Title: MTO2017 915iS Intercooler Mounting Assembly		
AG-SB-2020-03-B-EN		Compliance Category:
Applicability		A – MANDATORY B – RECOMMENDED C – OPTIONAL
Aircraft type & model: AutoGyro MTO2017	Affected Serial number(s): All MTO2017 fitted with the Rotax 915iS engine	
The maintenance manual to be referenced is this stated or subsequent issue.		As per AutoGyro website
This form is the response from AutoGyro GmbH either against a problem found in the product in service requiring a containment or rectification action, or as service information for aircraft modification incorporation. For help, contact AutoGyro on 49(0)5121 88056-00, or email airworthiness@auto-gyro.com.

This service bulletin provides instructions on how to replace the intercooler mounting assembly.

(Pic. 1)

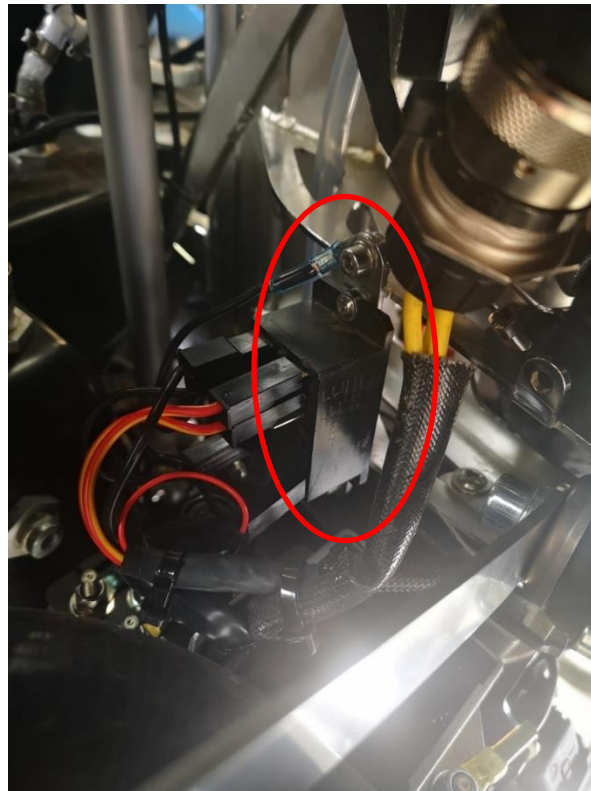
3. Support the engine using its lifting points. Rotax 915 series installation manual ch. 10-10-00 'Engine Handling' refers.
4. Disassemble the blow-off valve from the upper left engine mount (Pic. 1) and secure in an appropriate position to allow access to the engine mounting bolt head.

(Pic. 2)

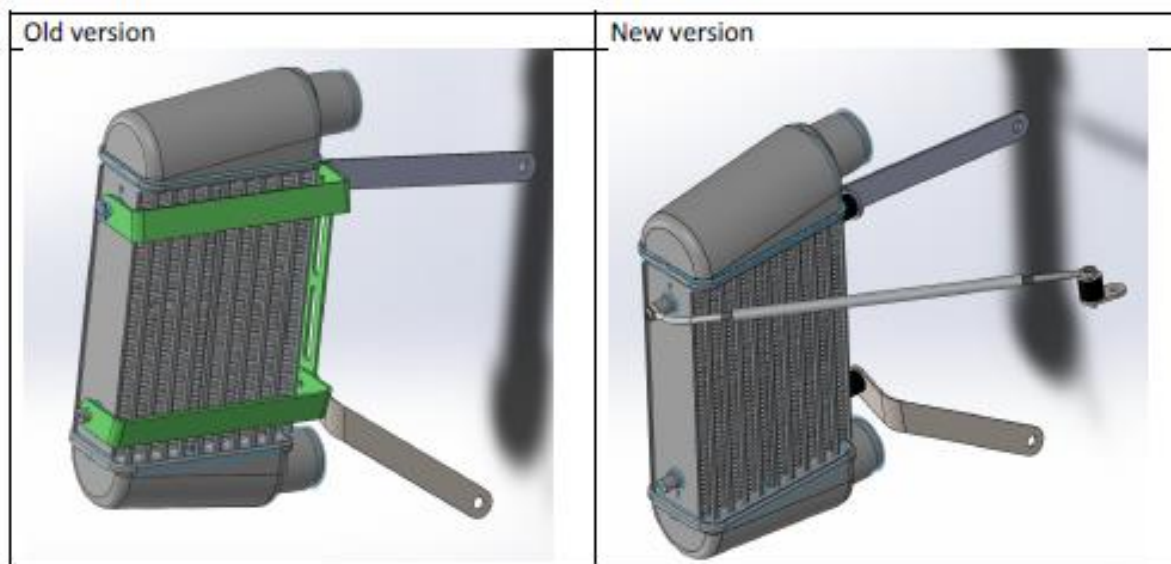
5. Disassemble the relay from the lower left engine mount (pic. 2) and secure in an appropriate position to allow access to the engine mounting bolt head.

(Pic. 3)

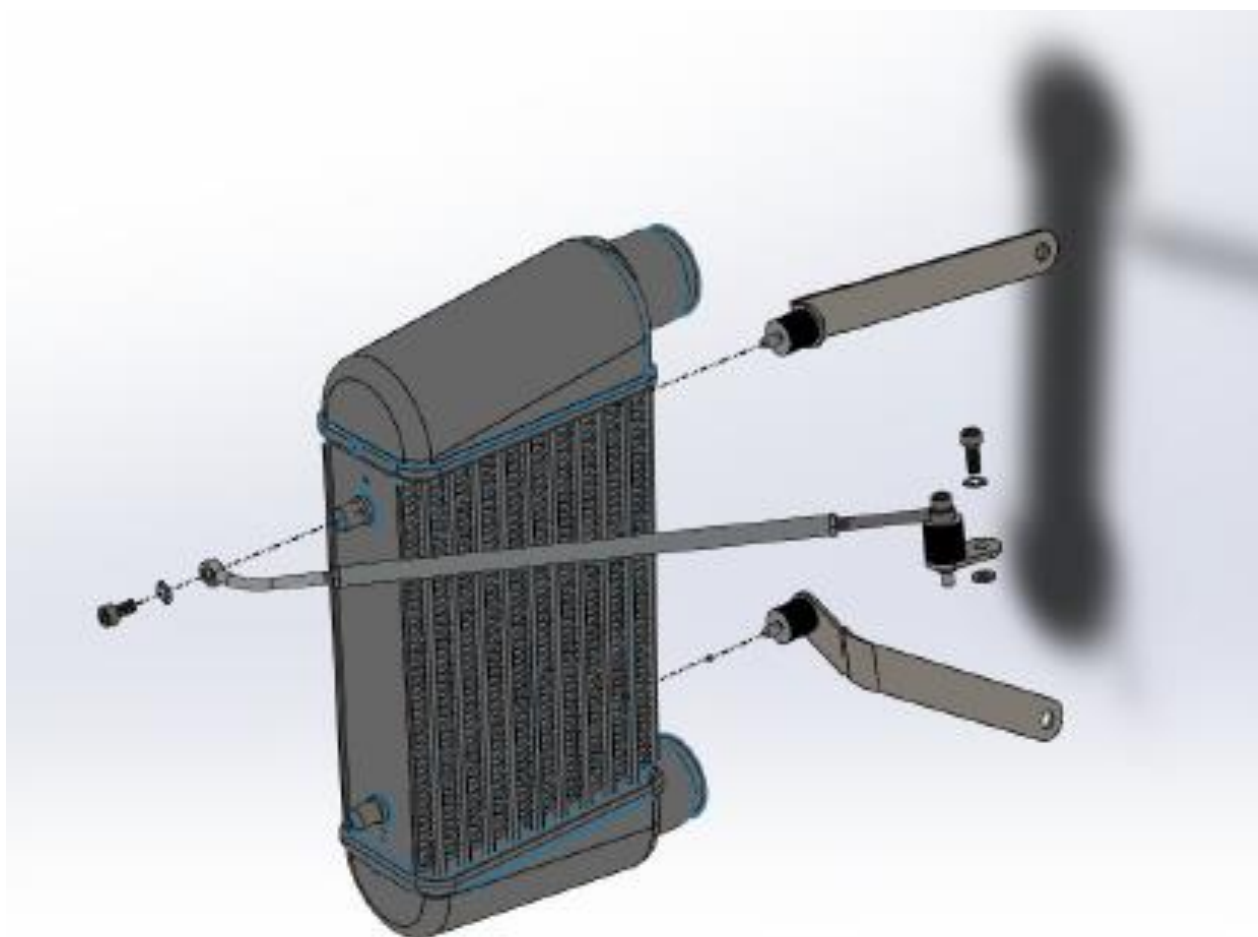
6. Remove the intercooler support frame (Pic. 3 – old version, green items)
7. Ensure the engine is supported and remove the upper and lower engine mounting bolts in accordance with AMM Job Card 71-20-00 8-1.

(Pic. 4)

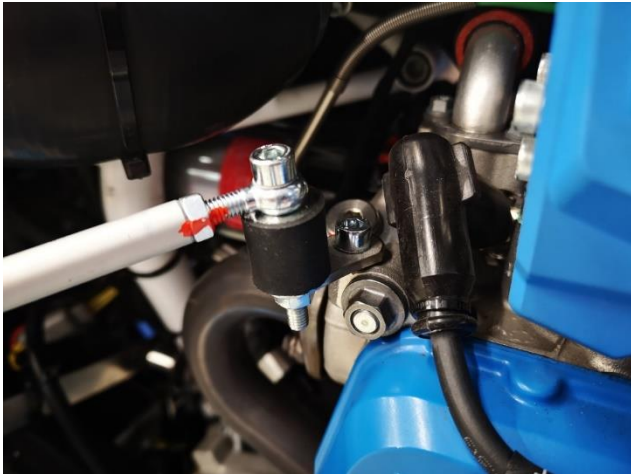
8. Remove the intercooler support arms from the engine bolts.
9. Assemble the new intercooler support assembly arms from set 47913 to the upper and lower engine mounting bolts as per the diagram in Pic. 4.

10. Re-assemble the engine mounting bolts and intercooler support arm assembly iaw AMM Job Card 71-20-00 8-1 and the assembly drawing in Pic. 4. Tighten hand tight so that the arms are still able to be orientated to the intercooler.

11. Assemble the arms to the intercooler. All bolts should be assembled using Loctite 243. Ensure there is no tension in the arms between engine and intercooler and tighten the engine mounting bolts to 39Nm. The arms may require a small amount of geometrical adjustment to achieve this.
